HAWP 10-88

APPLICATION FOR HISTORIC AREA WORK PERMIT

LOCAL ADVISORY COMMITTEE REVIEW FORM

c. Address of Property: 10001 PRATT PL.
SILVER SPRING, MD. 20910

BUILDING LOCATION SURVEY
 LOT 40 BLOCK 29
CAPITOL VIEW PARK

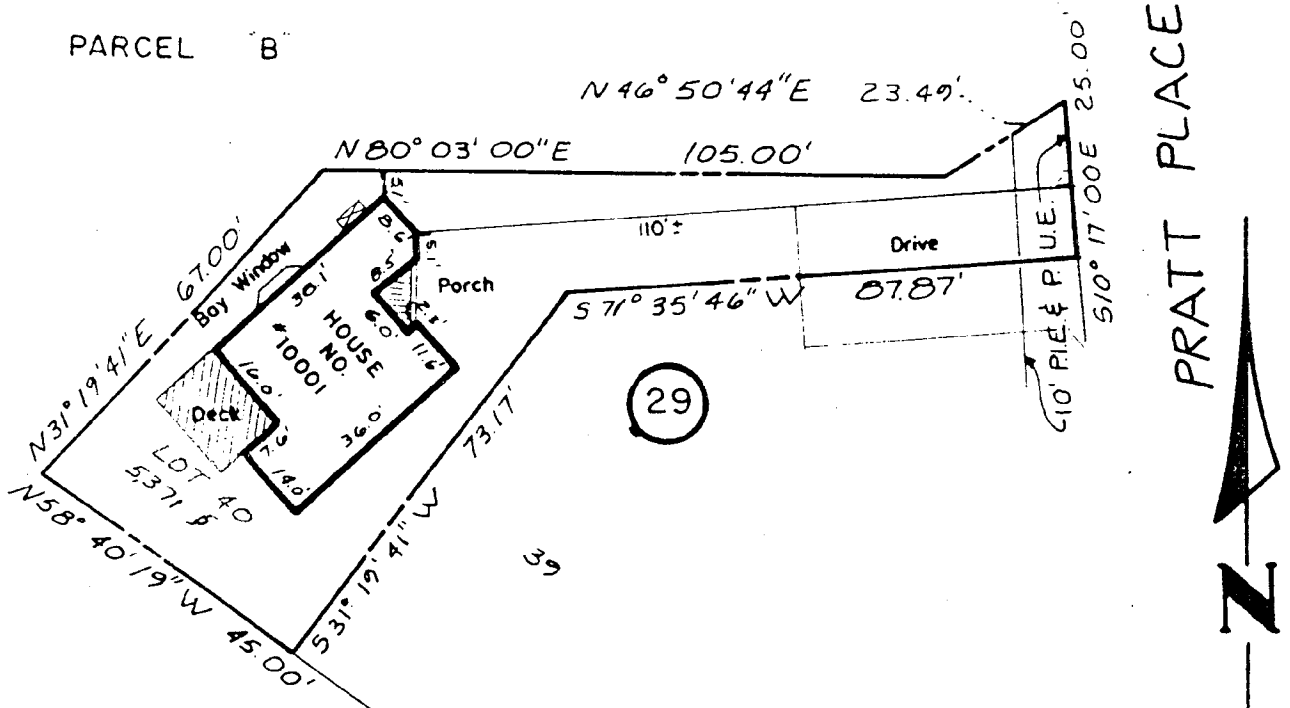
building footprint should meet 35% max. requirement.

ROOF

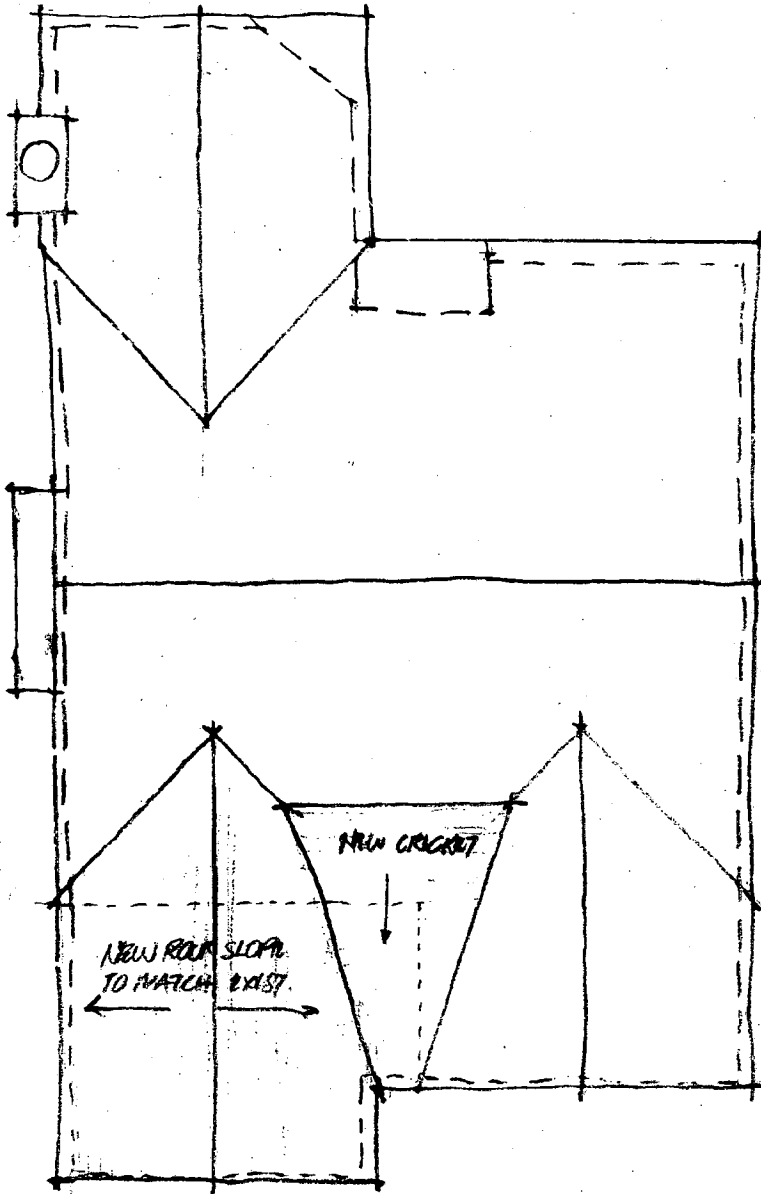
should respect window/door type style configuration as per sketch, and siding to match original. also roof plan enclosed.
